Re: Docket No. 70-925; License No. SNM-928  
Survey of Sediment/Spoils Mixture from 1206 Drainage in Subarea B

ATTACHMENT 1  
PROPOSED REVISED DRAWINGS FROM APPENDIX J-2  
*FACILITY DECOMMISSIONING PLAN – REV 1*

ATTACHMENT 2  
PROPOSED REVISIONS TO SECTION 8.2.4  
*FACILITY DECOMMISSIONING PLAN – REV 1*

**Cimarron Environmental Response Trust**  
OVERALL SITE PLAN AND SHEET LAYOUT KEY

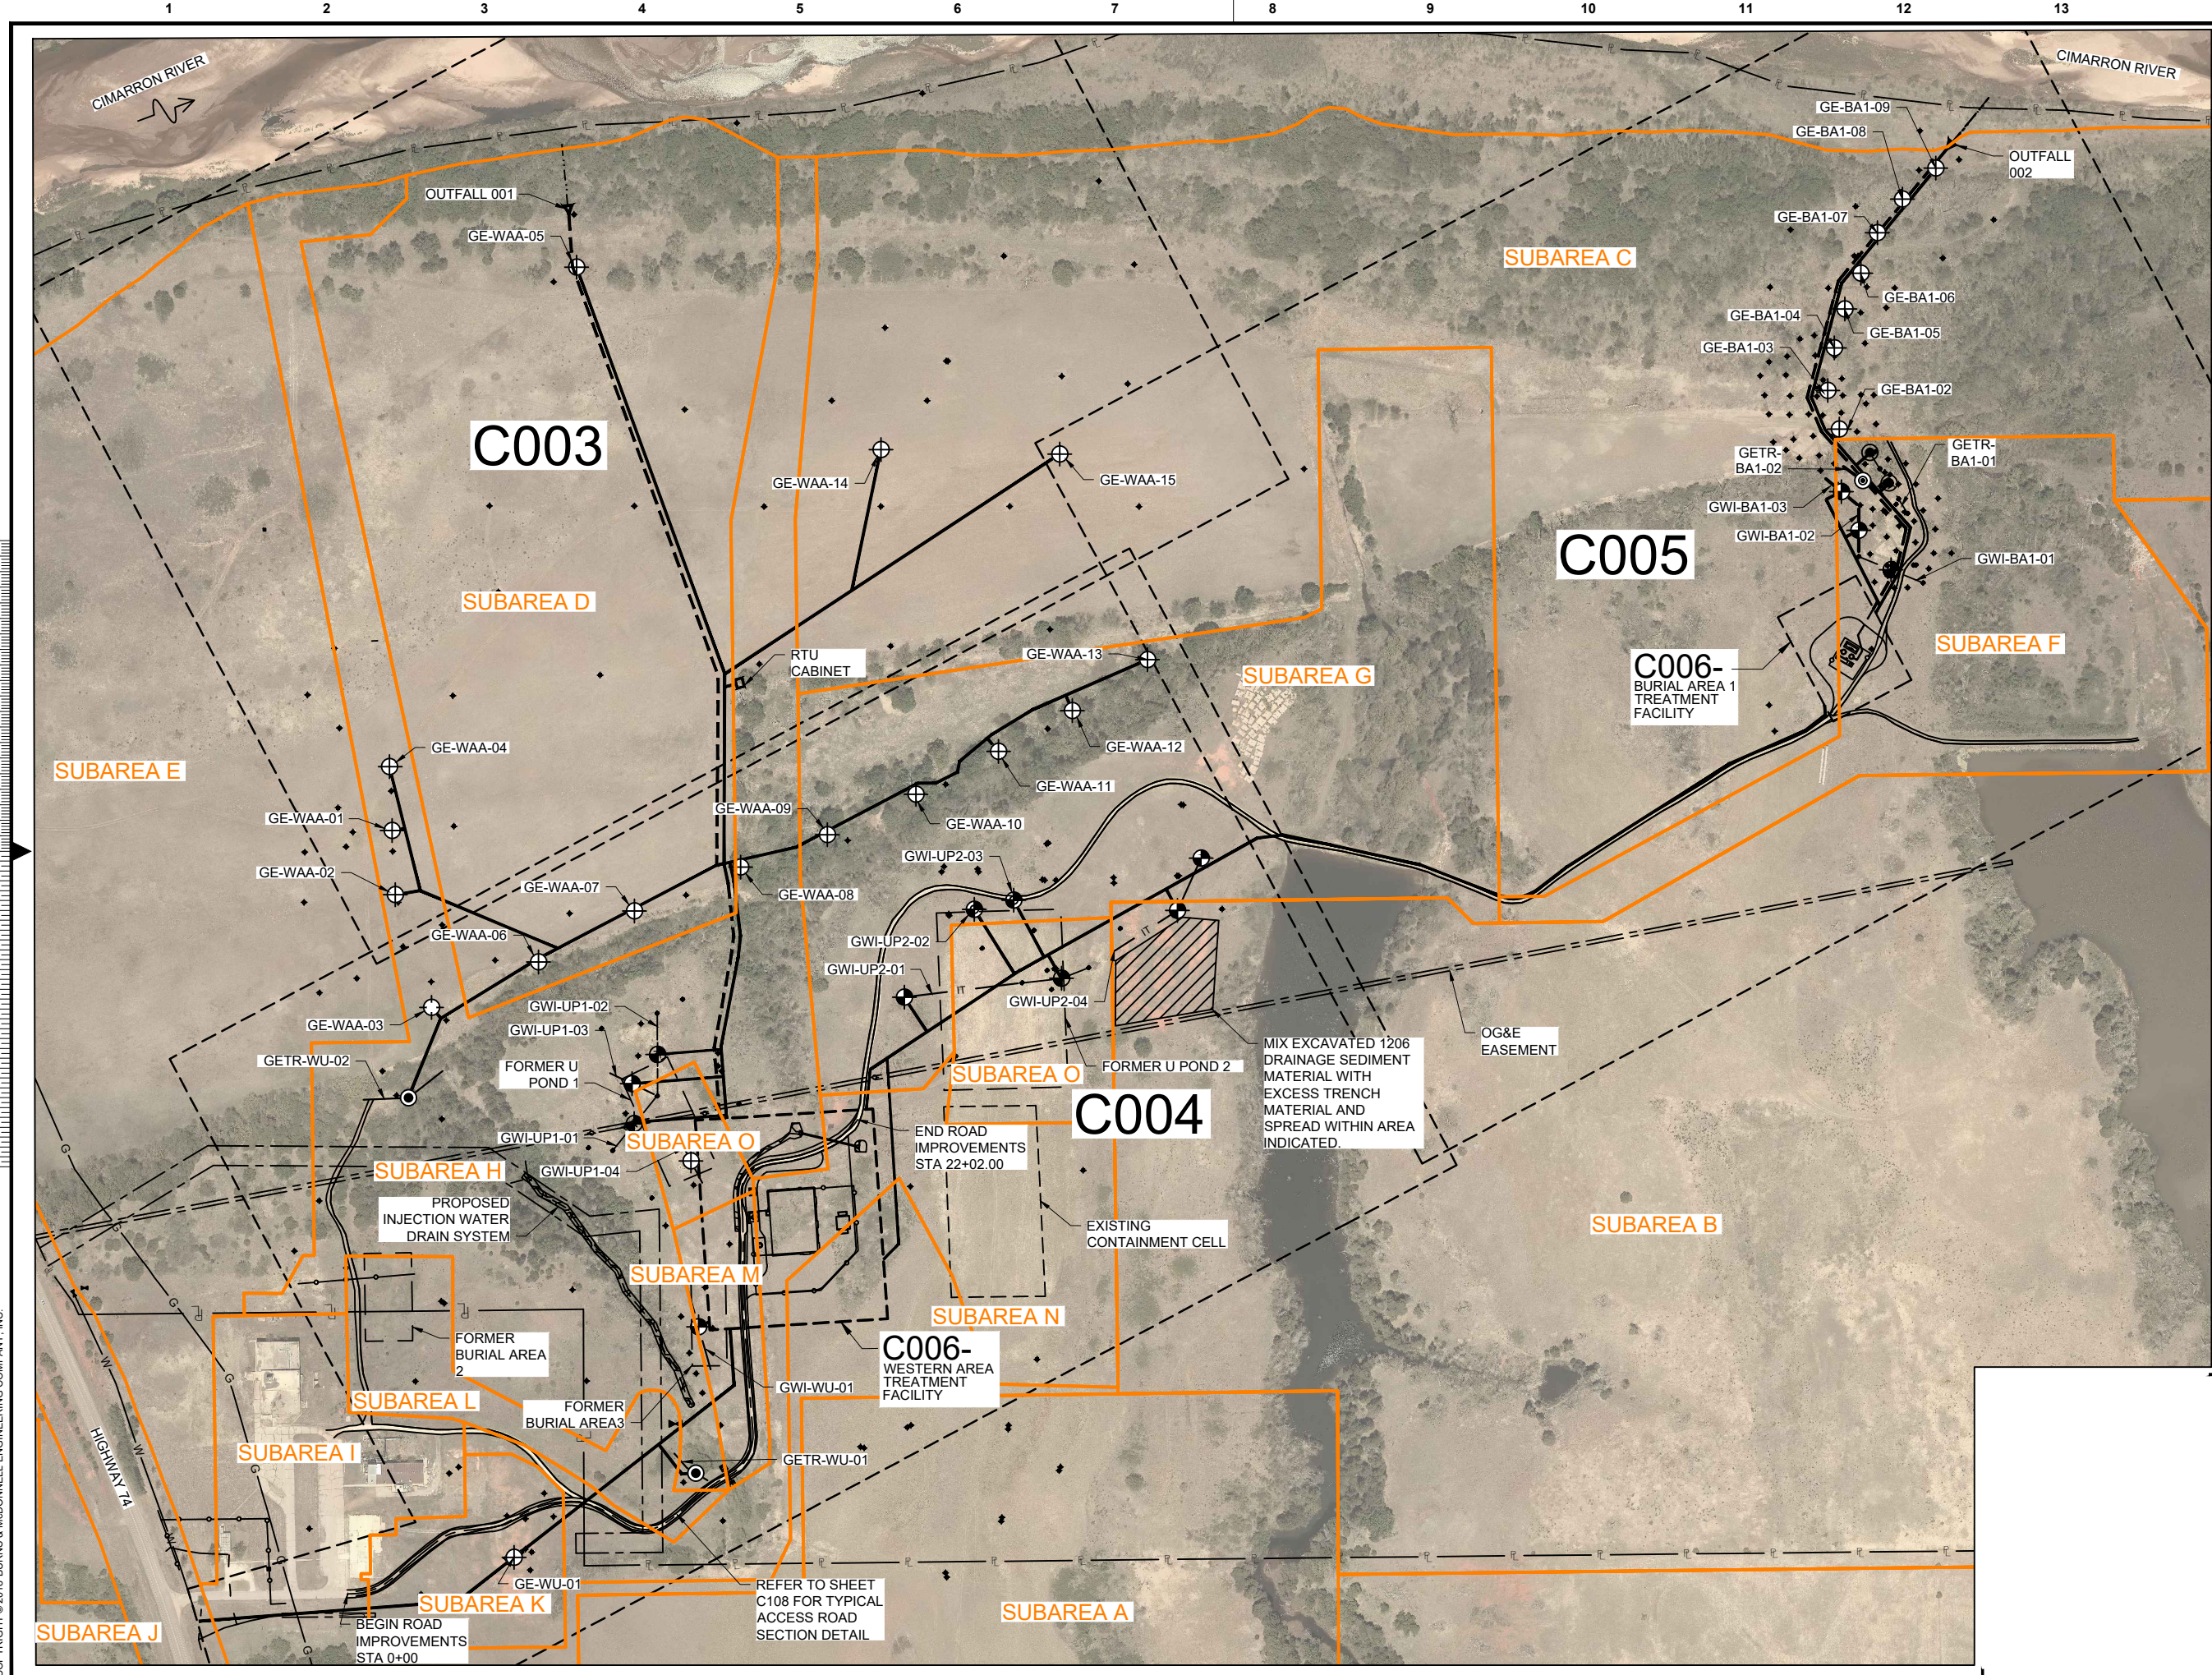
The radiological survey described herein is expected to confirm that no sediment/spoils mixture exceeding the Criterion will be present in Subarea B, and Subarea B will remain released for unrestricted use. Drawings BMCD-GWREMEDIATION-C002 and BMCD-GWREMEDIATION-C004 from Appendix K2 of the DP have been revised to show the location of the laydown area and are provided as Attachment 1 to this letter.

Drawing BMCD-GWREMEDIATION-C002 includes the outlines of the Subareas for your convenience. Proposed revisions to the “1206-NORTH” part of Section 8.2.4 of the DP, providing additional information on the management of sediment removed from the 1206 Drainages, and referencing the survey plan described herein, are provided as Attachment 2 to this letter.

**Cimarron Environmental Response Trust**  
PARTIAL SITE PLAN - SOUTH

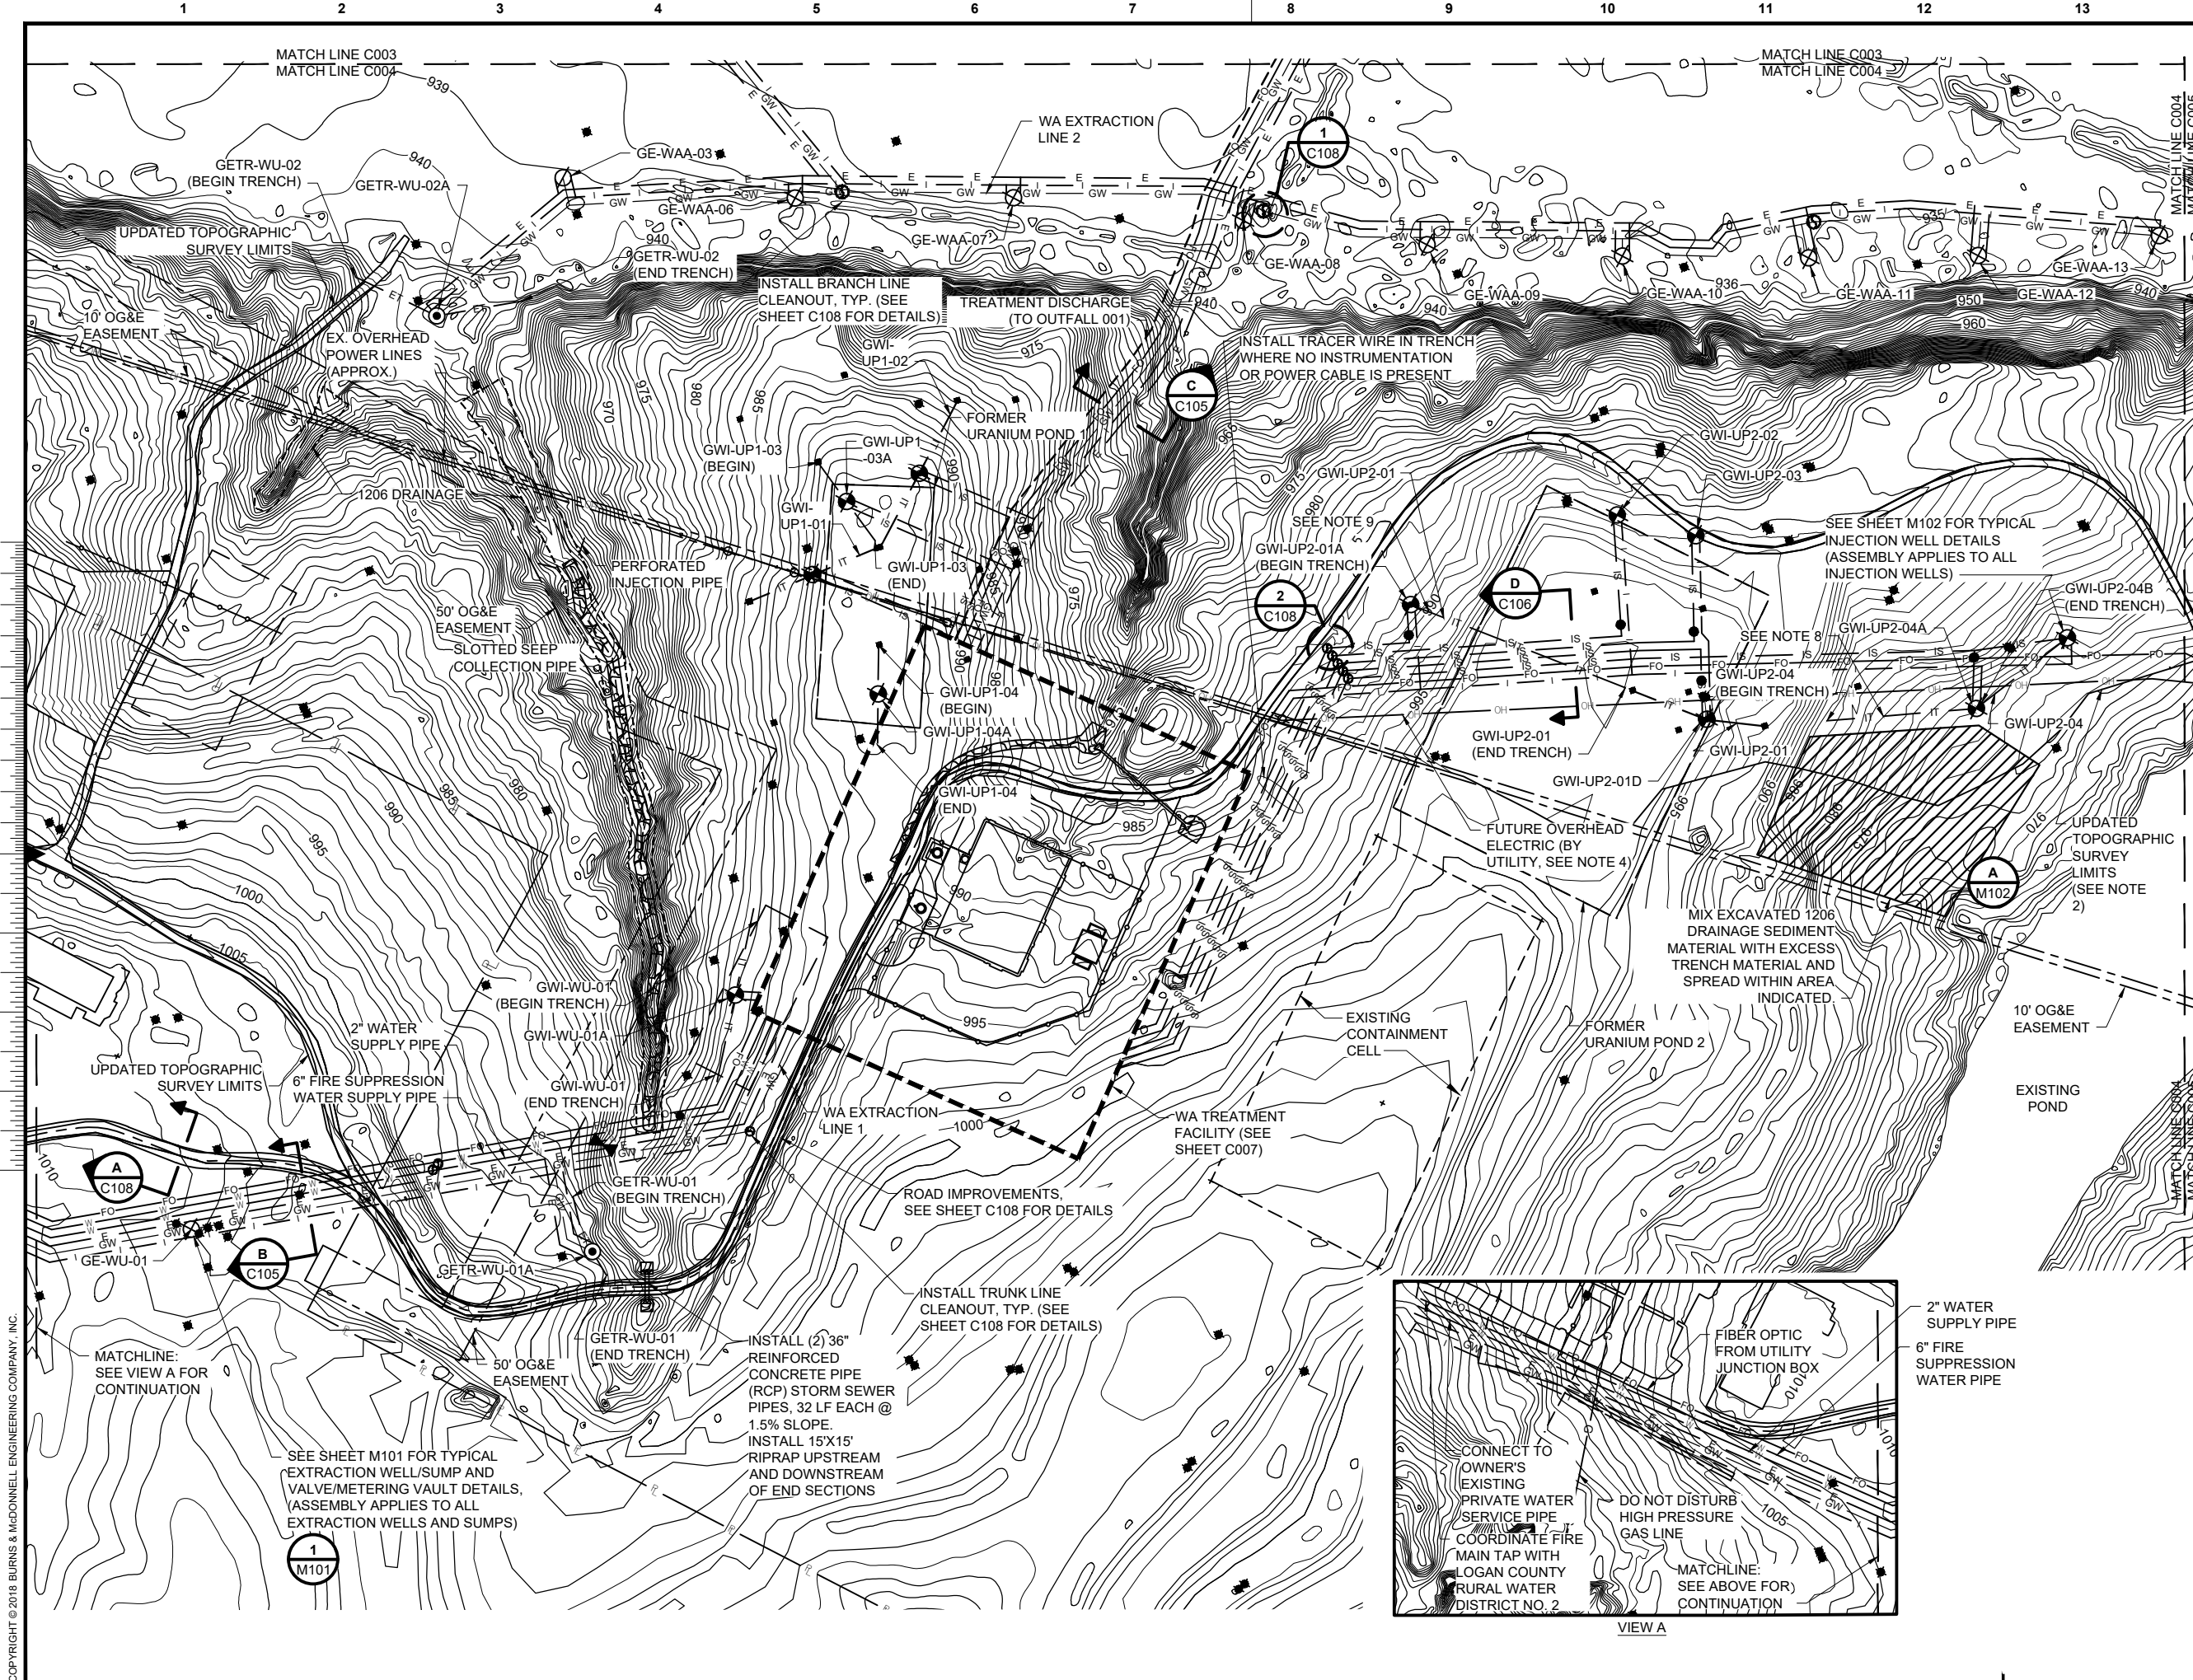
To facilitate the transfer of seepage from WU-BA3 to GETR-WU-02, a slotted pipe will be installed in the east branch of the 1206 drainage to convey the seepage directly to the transition zone material in which GETR-WU-02 is constructed. The same non-reactive gravel used in the construction of injection and extraction trenches will be used as backfill to maintain the integrity of the drainage channel and protect the slotted pipe. The extent of sediment excavation and the installation of the slotted pipe and gravel backfill are shown on Drawing C004 (Appendix J-2).
